MWO 9-2320-272-20-6

### FUEL TANK VENTILATION KIT MODIFICATION WORK ORDER

#### MODIFICATION OF 5-TON M939 AND M939A1 SERIES TRUCKS

1 February 1996

FIGURE 1

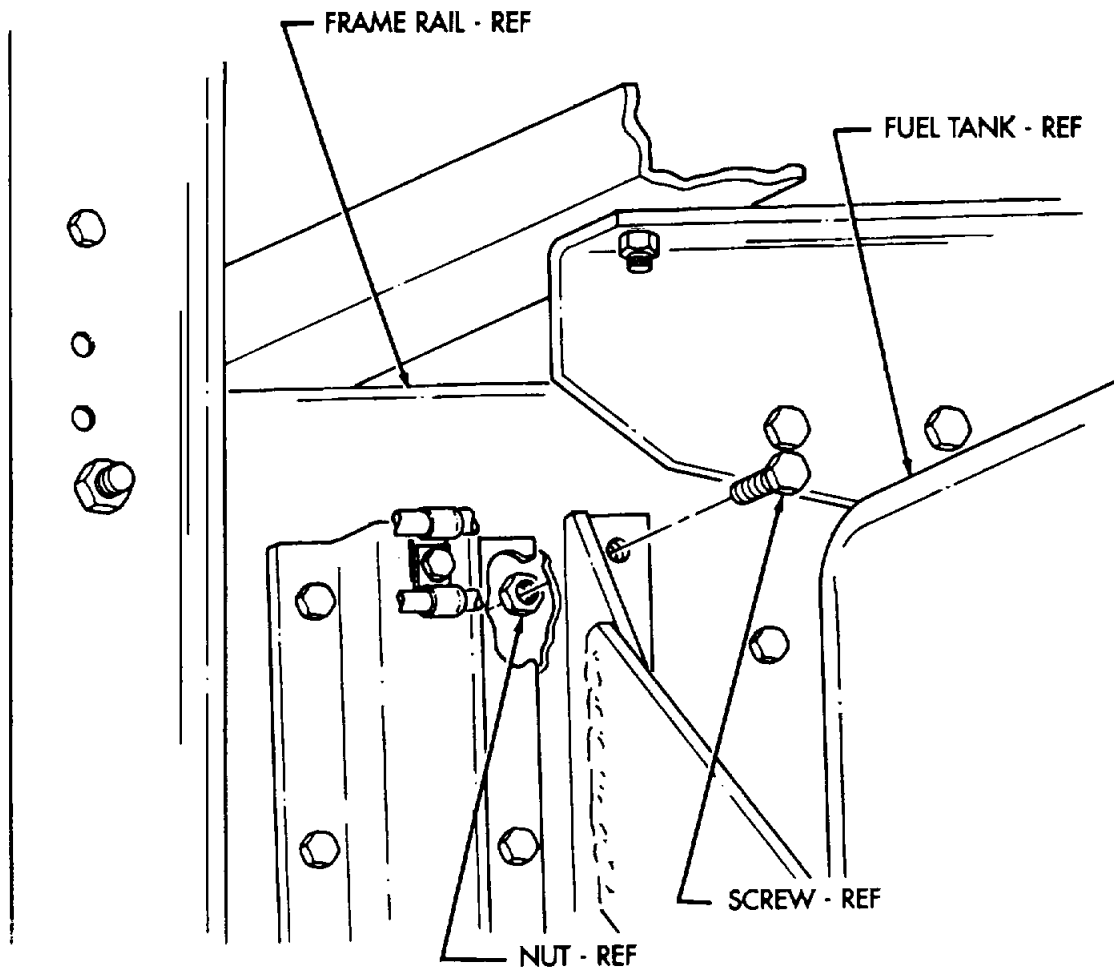
- (1) Disconnect battery ground cables (TM 9-2320-272-20-1).
- (2) Remove tachometer pulse sender unit (TM 9-2320-272-20-1).
- (3) Remove nut and screw from frame rail as shown in figure 1. Set nut and screw aside for disposition per para. 8.

FIGURE 2

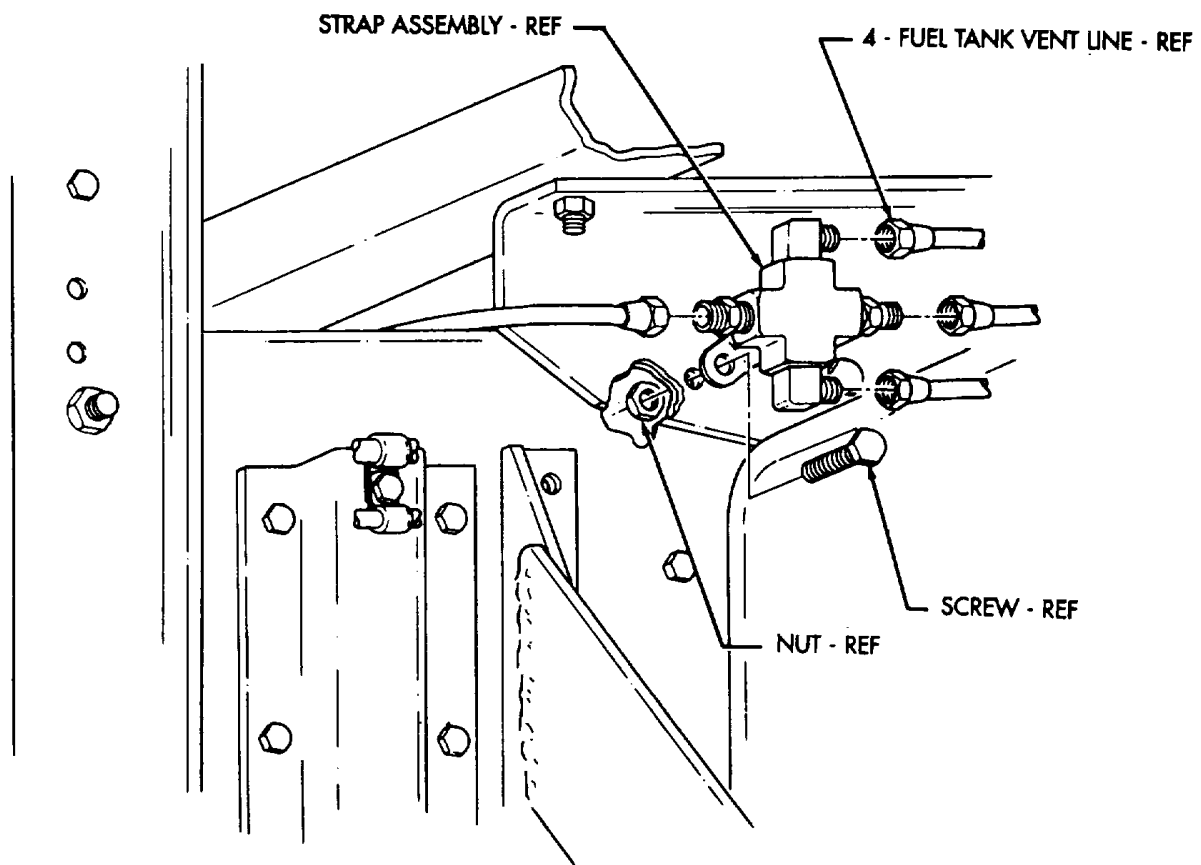
- (4) Disconnect four vent lines from strap assembly as shown in figure 2.
- (5) Remove nut, screw, and strap assembly from frame rail as shown in figure 2. Set nut, screw, and strap assembly aside for disposition per para. 8.

FIGURE 3

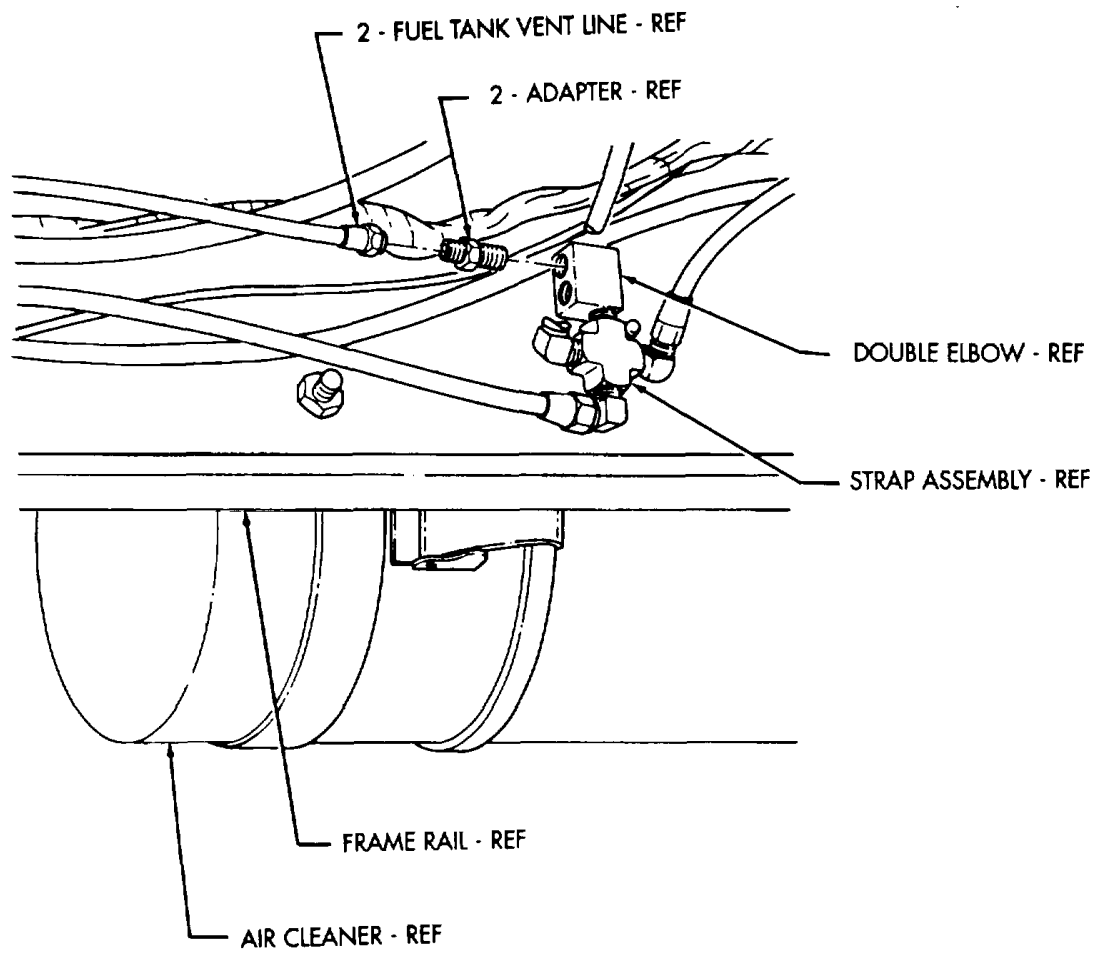
- (6) Remove two fuel tank vent lines and adapters from double elbow connected to strap assembly on inside frame of rail, opposite air cleaner as shown in figure 3. Set adapters aside for disposition per para. 8.

FIGURE 4

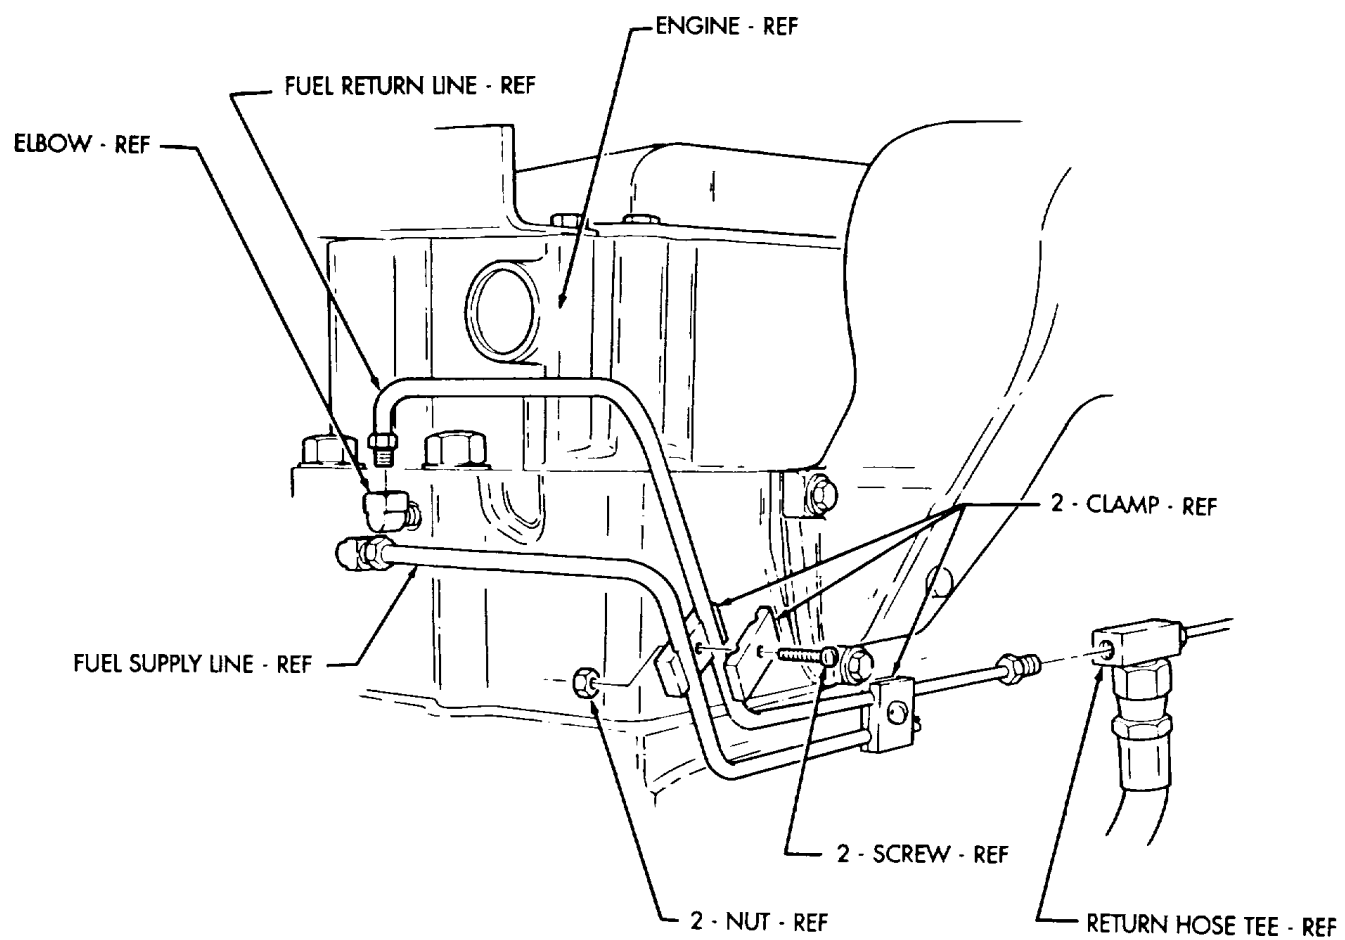
- (7) Remove two nuts, screws, and clamps from fuel return line and fuel supply line as shown in figure 4. Retain nuts, screws, and clamps for installation.

- (8) Disconnect fuel return line from return hose tee and elbow on front of engine as shown in figure 4.

FIGURE 5

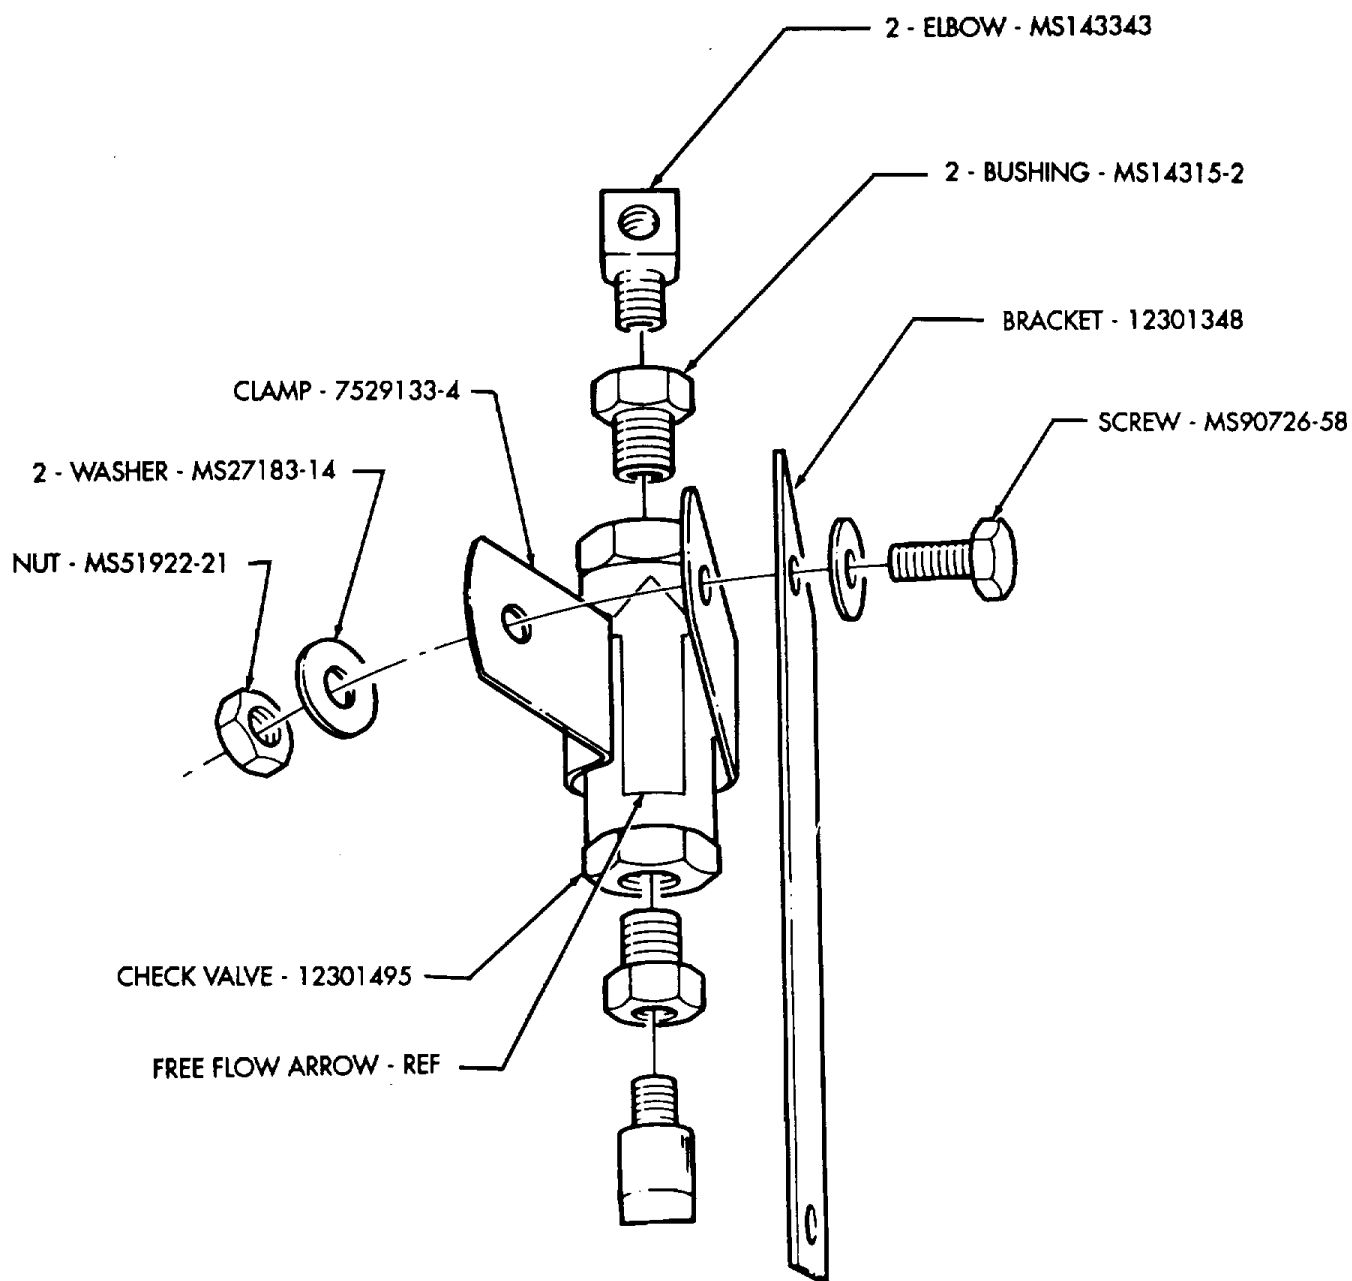
- (1) Install two MS14315-2 bushings in 12301495 check valve as shown in figure 5.

- (2) Install two MS143343 elbows on bushing as shown in figure 5.
- (3) Install 7529133-4 clamp on check valve as shown in figure 5.

Clamp must be installed on check valve with free flow arrow pointing up when installed on engine to prevent damage to internal engine components.

- (4) Install check valve on 12301348 bracket with MS90726-58 screw, two MS27183-14 washers, and MS51922-21 nut as shown in figure 5. Ensure free flow arrow on check valve points up.

FIGURE 6  
14

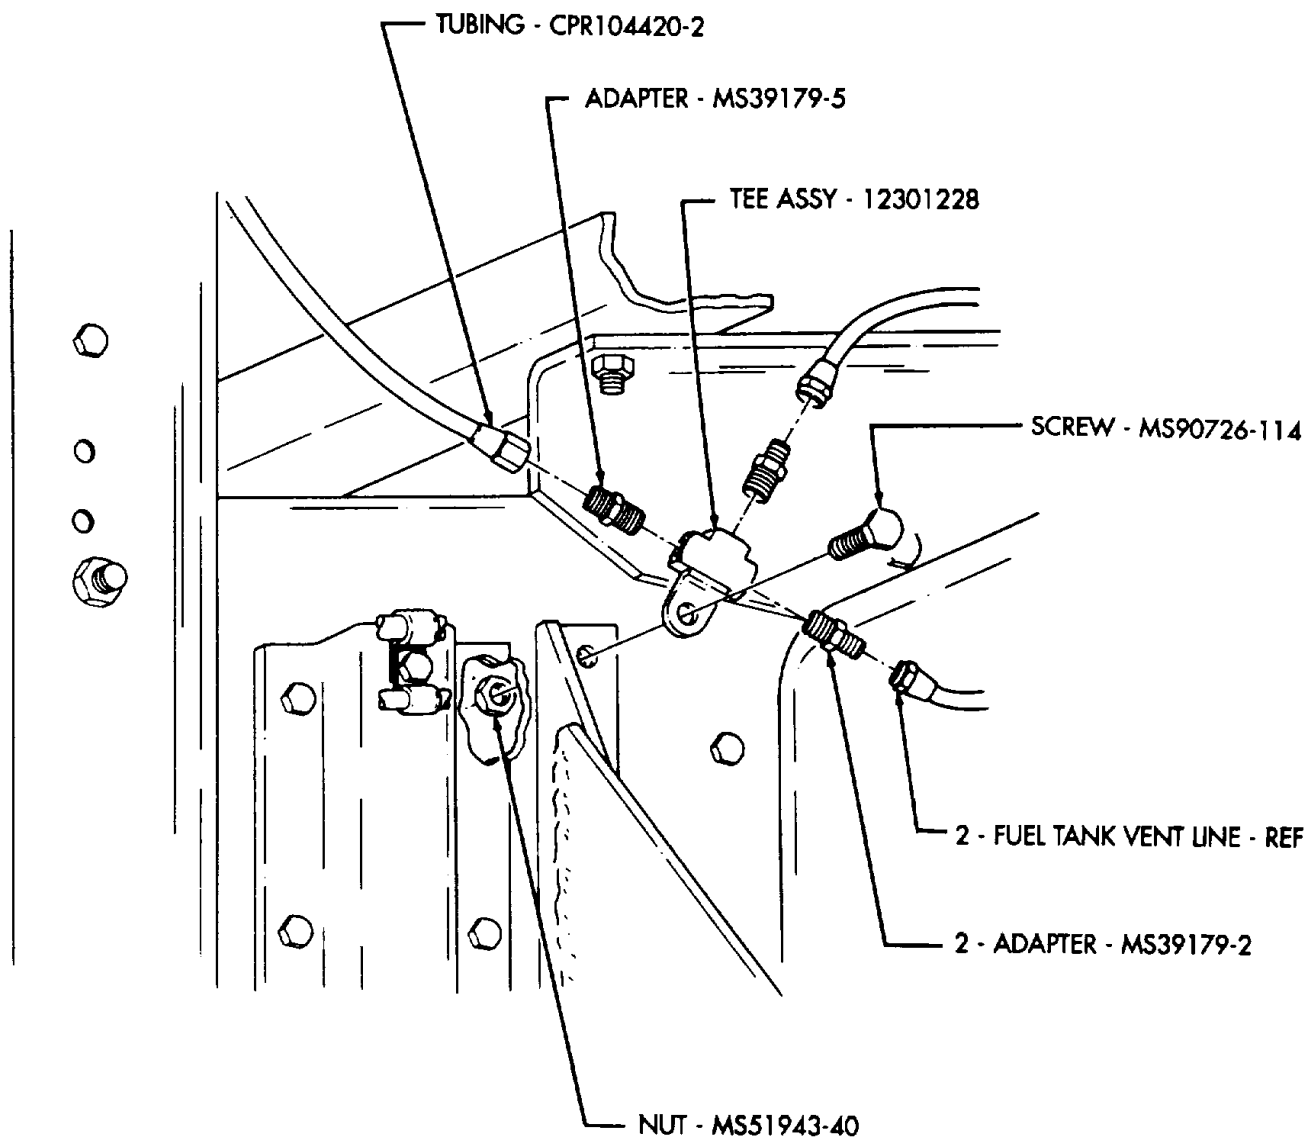
- (5) Install two MS39179-2 adapters on 12301228 tee assembly as shown in figure 6. Retain sleeves and nuts for installation.
- (6) Install two 12255985 double elbows on 12301228 tee assembly as shown in figure 7.

- (3) Connect two fuel tank vent lines from fuel tank-to-tee assembly as shown in figure 6.
- (4) Connect four fuel tank vent lines from fuel tanks-to-tee assembly as shown in figure 7.
- (5) Connect end of CPR104420-2 fuel tank vent line to tee assembly (12301228) as shown in figures 6 or 7.
- (6) Install tube (12301244) on air intake pipe with four MS35842-16 clamps as shown in figure 11. Remove excess clamp ends.
- (7) Connect end of fuel tank vent tubing (CPR104420-2) to tube (12301244) as shown in figure 11.

FIGURE 7

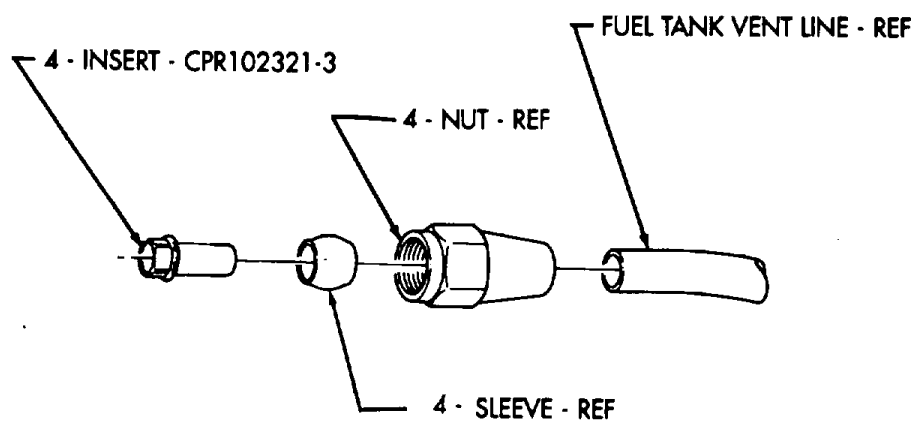
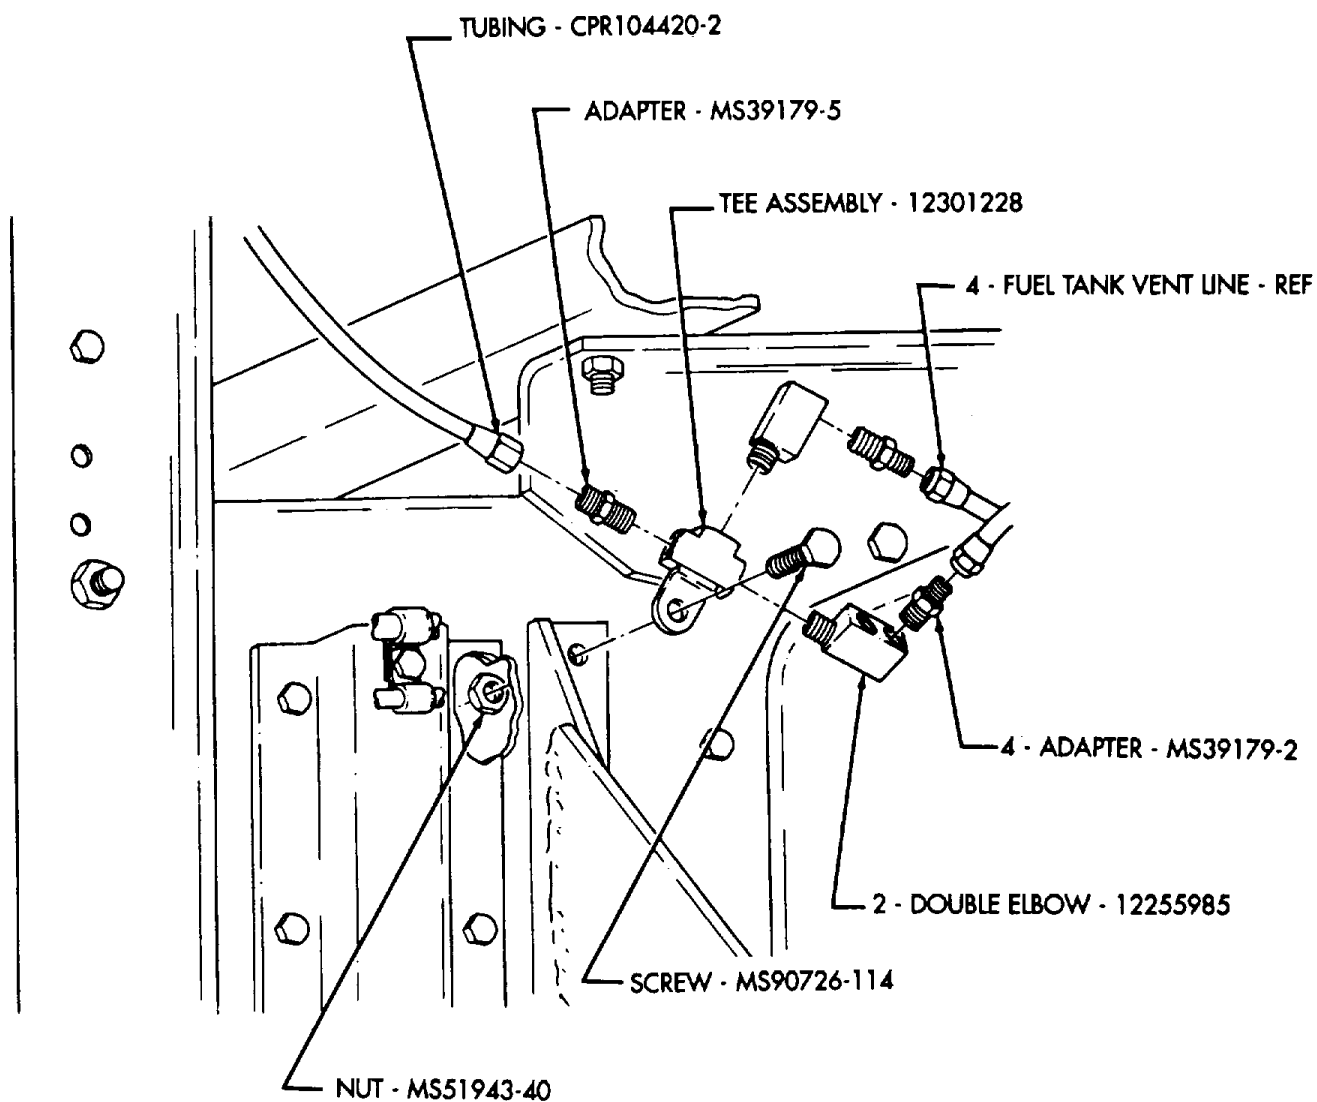
- (7) Install four MS39179-2 adapters on two double elbows as shown in figure 7.
- (8) Install MS39179-5 adapter on tee assembly as shown in figures 6 and 7. Retain sleeve and nut for use in step 12.

- Perform step (3) for vehicles equipped with single fuel tank.
- Perform step (4) for vehicles equipped with dual fuel tanks.
- If vent lines must be cut and shortened, use new nuts, sleeves, and CPR102321-3 inserts as shown in figure 7.
- Four CPR102321-3 inserts are required for vehicles equipped with dual fuel tanks.
